AIRAC
AIP
Supplement 97/25
16 OCT 2025

A D : MUAN/Muan INTL(RKJB)

CHANGE OF RWY 01/19 DECLARED DISTANCE

(Effective : 1600UTC 26 NOV 2025)

4. DIAGRAM

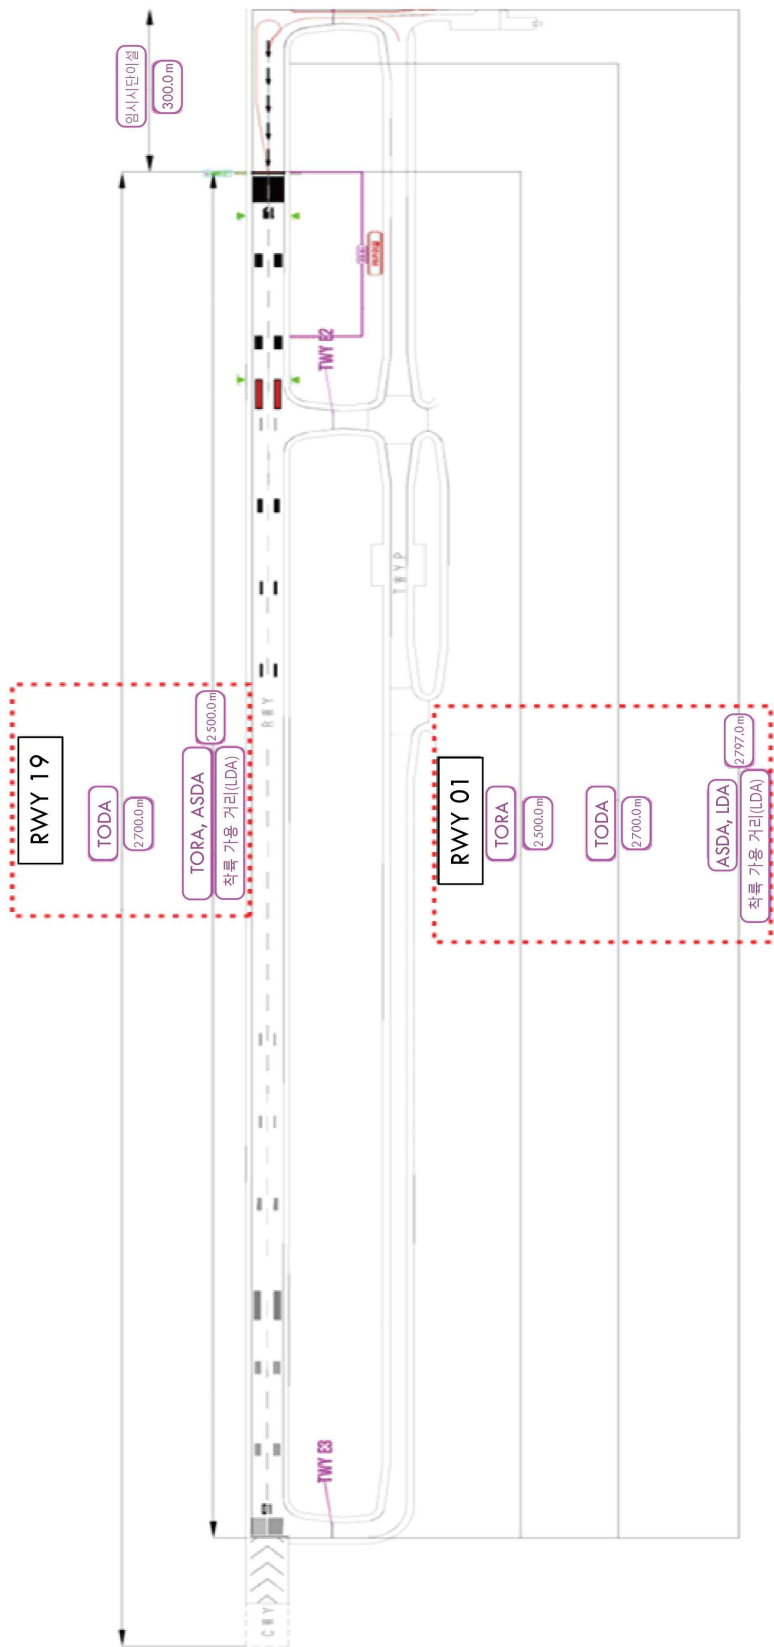
RWY 01/19 declared distance will be changed below.

TORA(m)	TODA(m)	ASDA(m)	LDA(m)	Remarks
RWY 01	2 500	2 700	2 797	2 797	NIL
RWY 19	2 500	2 700	2 500	2 500	NIL
RWY 19	2 057	2 257	2 057	2 057	Take-off from intersection with TWY E2

- (1) The ASDA and LDA for RWY 01 are not affected by displacement of RWY 19 THR.
(AIRAC AIP SUP 98/25(RWY 19 THRESHOLD DISPLACED BY 300 m))
- (2) Any change to the contents of these pages will be notified by NOTAM.
- (3) See the diagram below.
